Subject: Follow-up: July 17, 2018 Groundwater Modeling Workgroup – Response to Action Items GW-75, GW-76, GW-77, GW80 and GW-81

Please see the attached responses to Groundwater Modeling Workgroup action items GW-75, GW-76, GW-77, GW80 and GW-81 for your review and consideration.

CLIENT:	Resolution Copper	PROJECT:	3D Regional Groundwater Model	
JOB:	31400968.001	DRAWN:	CP	CHECKED: DO
DATE:	August 2018	FIGURE:	GW75-1

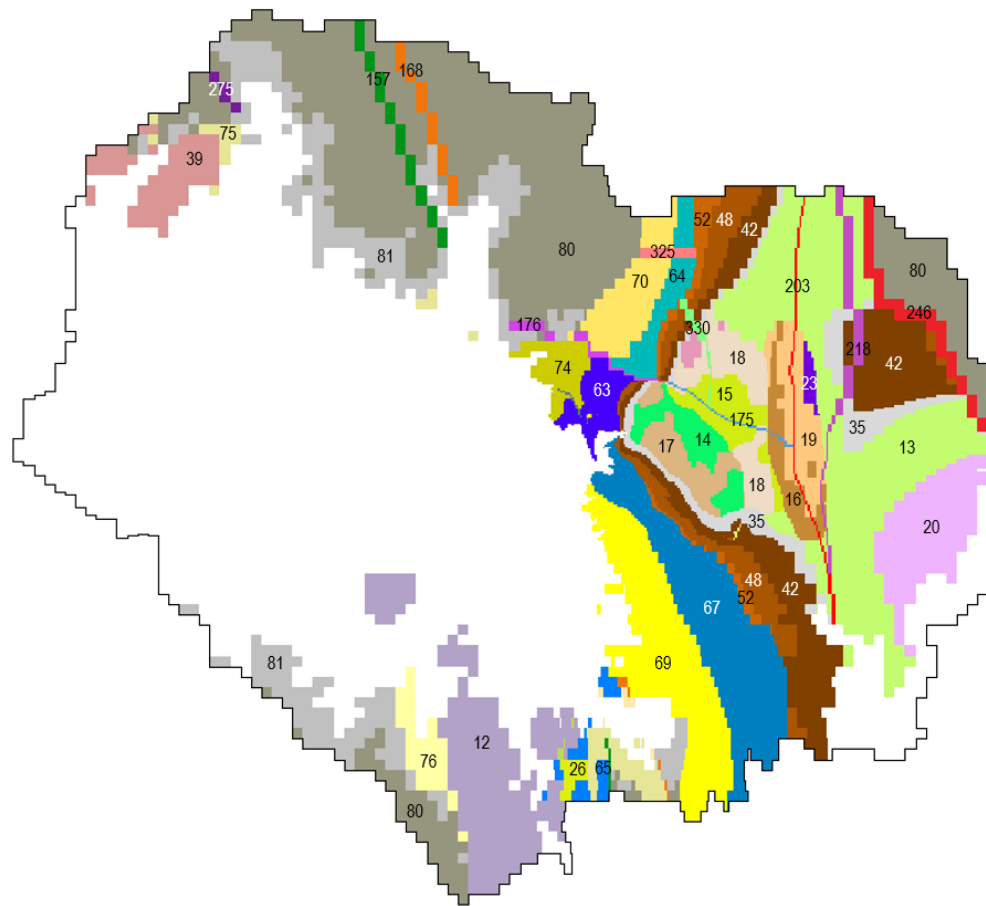
GW-75: Resubmit 6/18 information with elevations and units (ft/day) added

Resolution response: The requested item is contained in the attached information from WSP titled “*GW75 HGU Material Properties.pdf*”

PROJECT:	3D Regional Groundwater Model	FIGURE #:	GW76
CLIENT:	Resolution Copper	PROJECT #:	31400968.001
DRAWN:	CP	CHECKED:	DO
		DATE:	August 2018

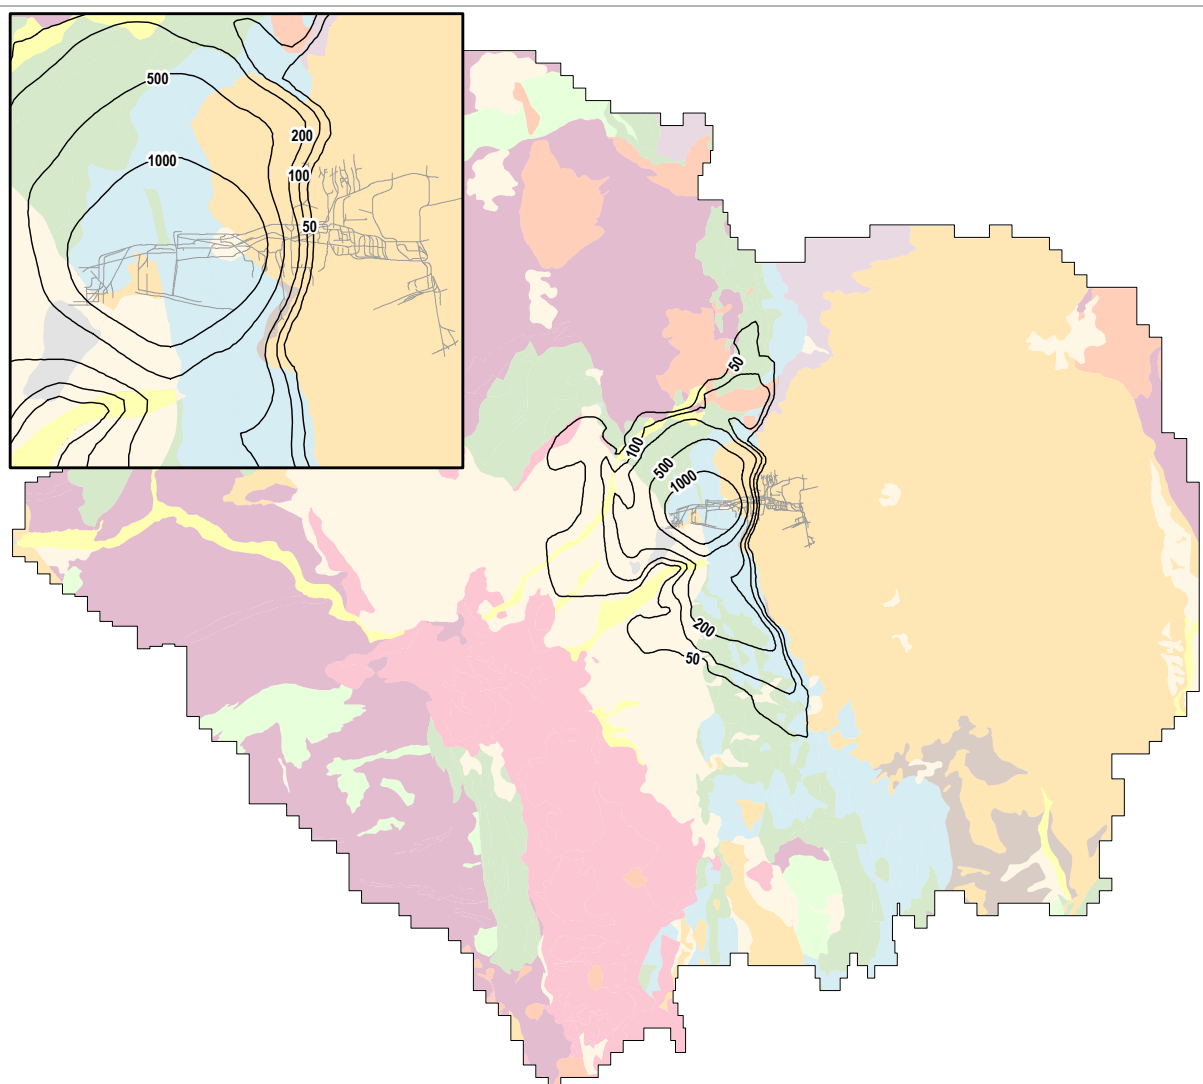
GW-76: Submit water level map that shows the difference between previously submitted 1910 and 2017 maps.

Resolution response: The requested item is contained in the attached WSP figure titled “*GW76 Historical Drawdown.pdf*.”

FIGURE #: GW77

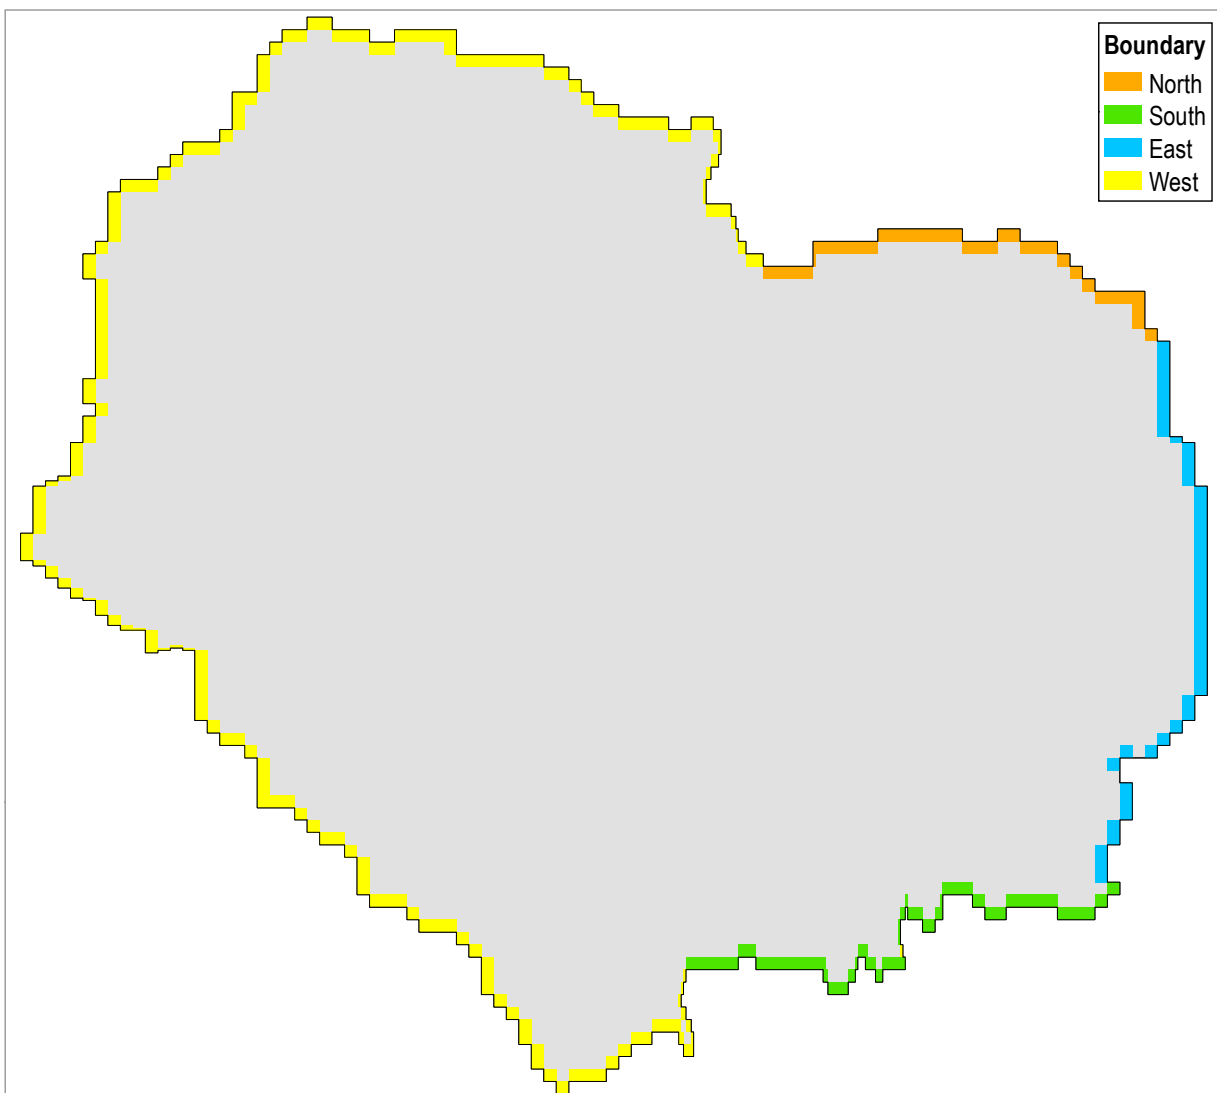
GW-77: Provide further detail on the boundary fluxes for GHB vs no flow comparison. Specifically compare flux change (<5gpm) to model pumping stress.

Resolution response: The attached WSP figure titled “*GW77 GHB Flux.pdf*” shows the GHB boundary fluxes at three snapshots (Historical, Life of Mine, post-closure). An additional column is included comparing the flowrates across the model boundaries against average dewatering flowrates from the Resolution Mine (ie. the main stress on the system) in the Life of Mine model; expressed as percentage of flow.
